**AL KASIK LOCATION COMMAND
AL KASIK, IRAQ**

**SIGIR PA-09-182
OCTOBER 16, 2009**

SUBJECT: Report on the Al Kasik Location Command, Al Kasik, Iraq (SIGIR Report
Number PA-09-182)

Site Photo 11. Site grading for diesel storage at the distribution point

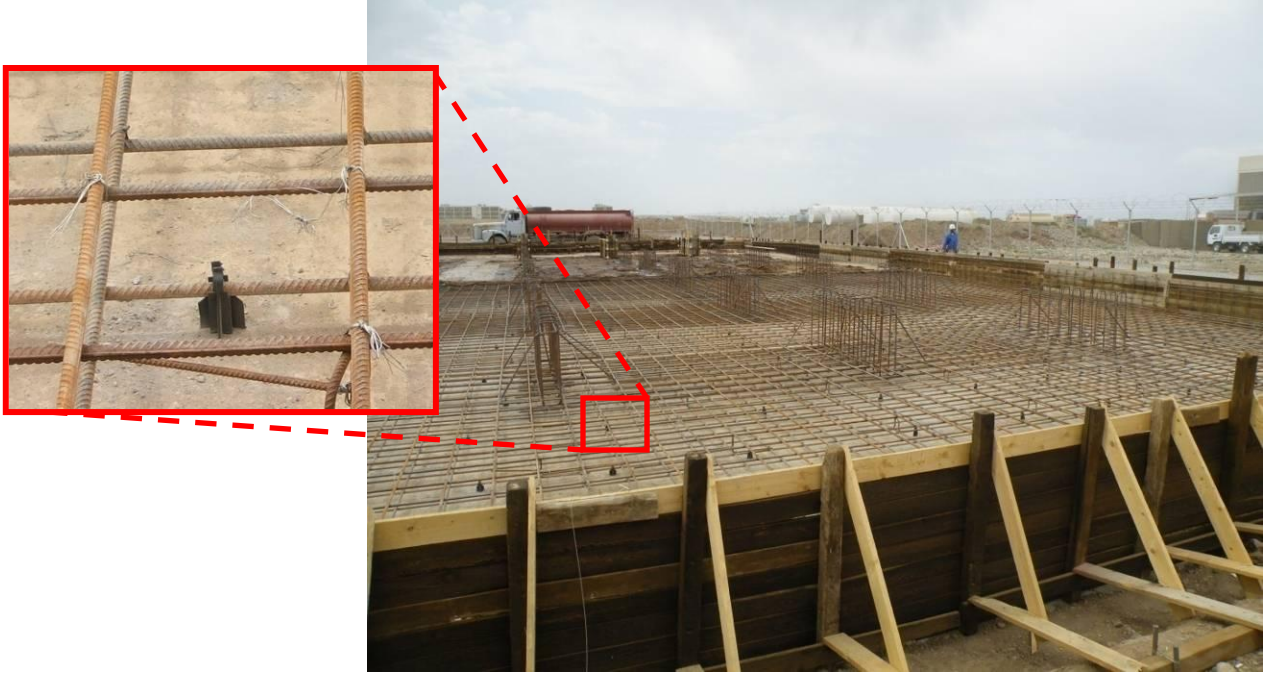
During the inspection of the raft foundation, SIGIR discovered one issue. It appeared that the contractor placed a construction joint near the middle of the foundation slab. It did not appear that provisions were made to continue the reinforcing steel through the construction joint or provide fuel proofing. There was also no evidence of a shear transfer mechanism at the joint—such as dowels or a shear key—and no fuel stop was noted.

The GRN Mosul Area Office personnel stated that the contractor would perform a final check of the rack system after construction completion to verify that all bracing is installed and that all legs are securely fastened to the floor slab. The other issues would be addressed throughout the project, and corrective action would be taken as necessary.
